- ORIGINATION FORM -

Proposed Revisions to a Standard Plans Index

Contact Information:Standard Plans:Date: January 13, 2022Index Number: 455-440Originator: Joshua TurleySheet Number (s): 1 and 2 of 4Phone: (850) 414-4475Index Title: PRECAST CONCRETE SHEET PILE WALLEmail: joshua.turley@dot.state.fl.us(CFRP/GFRP & HSSS/GFRP)Summary of the changes:Index Title: PRECAST CONCRETE SHEET PILE WALL

PILE WALL	INDEX	SHEET
RP)	455-440	1 of 4

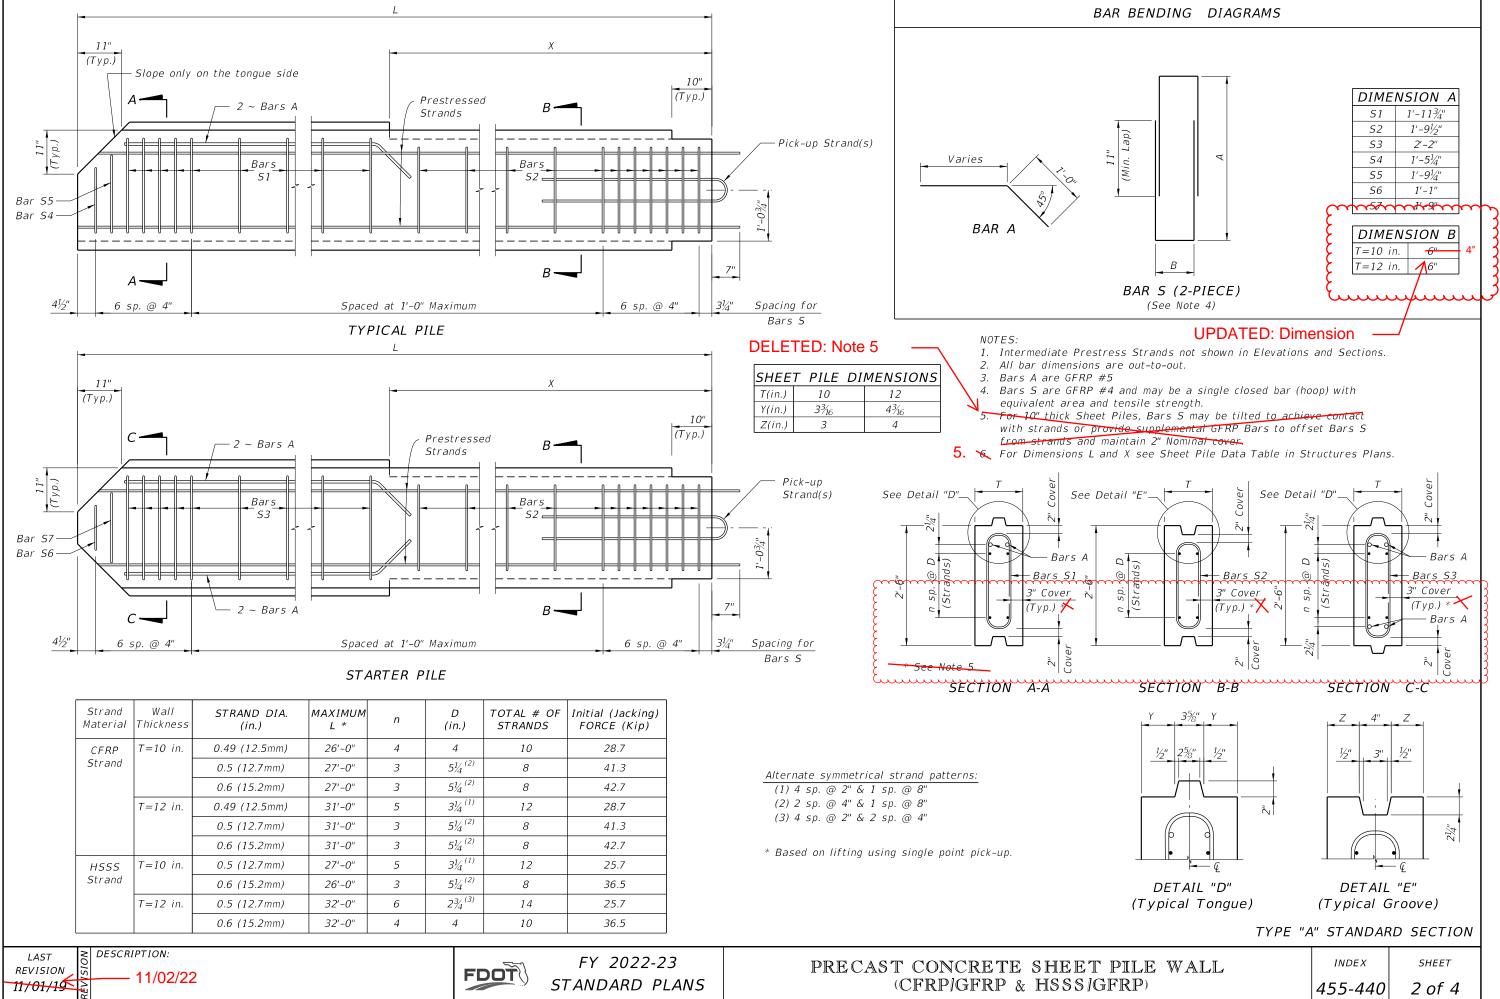
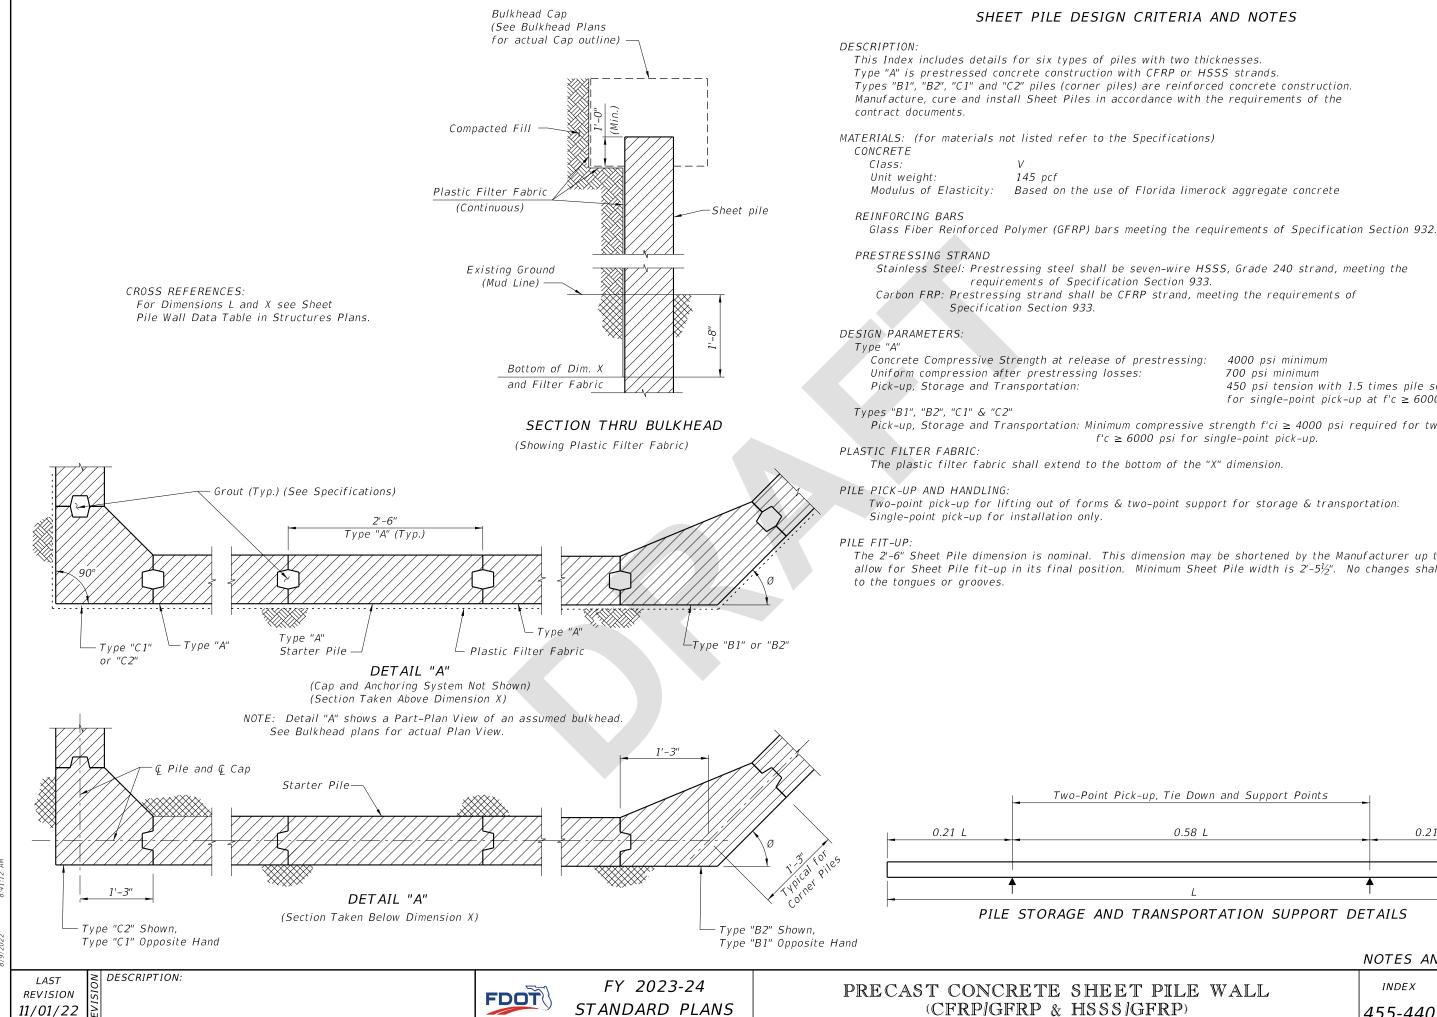
Sheet 1: Changed Class V (Special) concrete to Class V.

Sheet1: Department has eliminated Class V (Special)
